HISTORIC LANDMARK COMMISSION STAFF REPORT

Meck Residence Major Alterations 505 E Third Avenue PLNHLC2012-00384 July 19, 2012

Applicant: Kimble Shaw, architect
representing Lena & Ron Meck,
owners

WEST ELEVATION STUDY
SCALE: 1/8" = 1'-0"

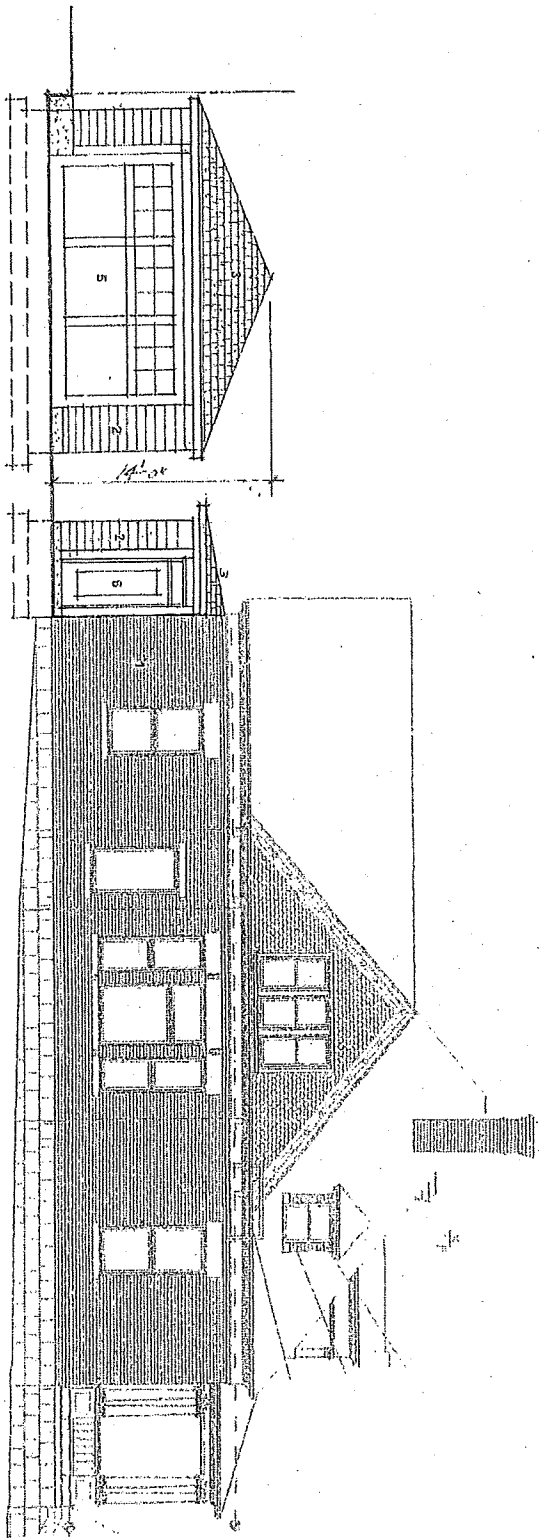
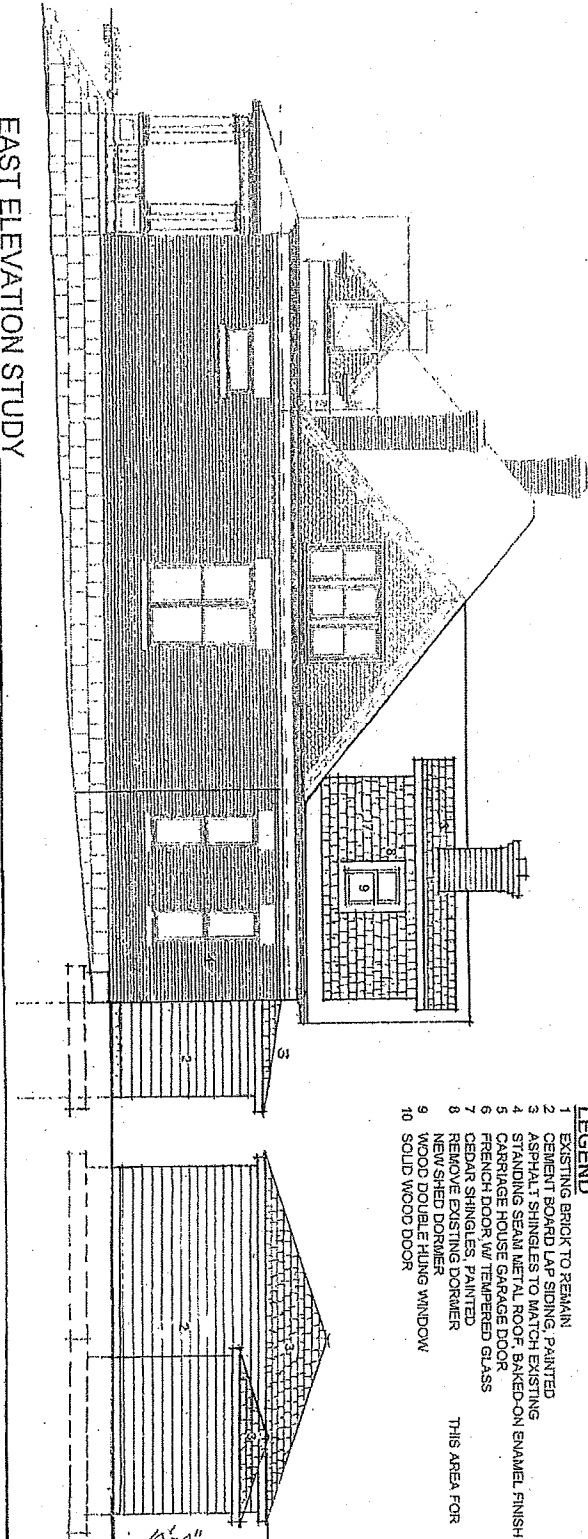
- a. Windows shall cover approximately 75% if the dormer’s face and siding and/or trim shall occupy the left over surface area.
2. Based on the analysis and findings of this report, it is the Planning Staff’s opinion that the proposal to demolish the accessory structure would fail to comply with the requisite number of standards (6) to demolish a “contributing” structure. If the Commission concurs with the Staff analysis and findings that two (2) of the standards are met then Staff recommends that it should be denied.

The essential form and roofline are important character defining features of this significant building and although the original form of the building could theoretically be restored, the shed dormer is out of scale with the rest of the building. Too much siding makes the dormer appear heavy and creates the impression that the dormer is too big for the house and no longer secondary to the primary roof. Staff is of the opinion that if windows covered approximately 75% of the dormer's face and the cladding and trim occupied the left over surface area, the shed dormer would not appear to overwhelm the main roof. Vertical proportion and window form are important in any addition. The Commission may also wish to consider a gabled dormer design.
